# Access Compliance Report

## Public Rights-of-Way

### (Curb Ramps)

Intersection ID: 16451	Main Street: HARTFORD_AV	Cross Street: HOLLIS_RD	Location: NE
ADA ID: 79A5B9AED7FE	Ramp Type: Para	Initial Pass/Fail: Fail	Overall Compliance: No
Severity Score: 13.75			
Codes/Mitigation Info/Possible Solution		Field Measurements/Component Compliance

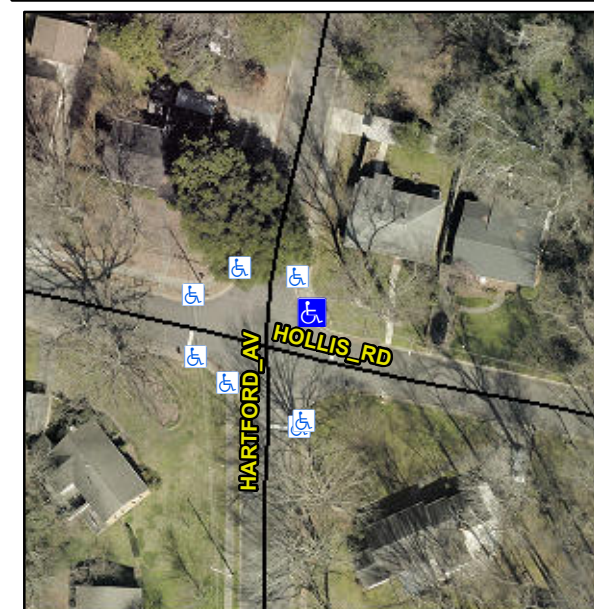
**R304.5.3, R304.3.2**

Compliance	Description	Data	Compliance	Description	Data
N/A	Ramp Length LT (in)	52.0	N/A	Ramp Length RT (in)	51.0
Yes	Ramp Width LT (in)	83.0	Yes	Ramp Width RT (in)	80.0
Yes	Ramp Slope LT (%)	5.1	No	Ramp Slope RT (%)	9.6
No	Ramp XSlope LT (%)	2.1	No	Ramp XSlope RT (%)	2.9
N/A	Landing Length (in)	N/A	N/A	DWS Provided?	N/A
N/A	Landing Width (in)	N/A	N/A	DWS Contrast?	N/A
N/A	Landing Slope (%)	N/A	N/A	DWS Length (in)	N/A
N/A	Landing X Slope (%)	N/A	N/A	DWS Full Width?	N/A
N/A	Landing Curb? (Y/N)	N/A	N/A	DWS Offset (in)	N/A
N/A	Shared Landing?	N/A			
N/A	Gutter Ponding?	N/A	N/A	Gutter Slope (%)	N/A
N/A	Gutter Lip Ht (in)	N/A	N/A	Gutter X Slope (%)	N/A
N/A	Painted X Walk1?	No	N/A	Painted X Walk2?	N/A
	X Walk 1 Direction	To S		X Walk 2 Direction	N/A
N/A	X Walk 1 Width (in)	N/A	N/A	X Walk 2 Width (in)	N/A
	X Walk 1 Slope (%)	1.9		X Walk 2 Slope (%)	N/A
	X Walk 1 X Slope (%)	2.0		X Walk 2 X Slope (%)	N/A
N/A	Ramp inside XWalk1?	N/A	N/A	Ramp inside XWalk2?	N/A

**Remove & Replace Entire Ramp.**
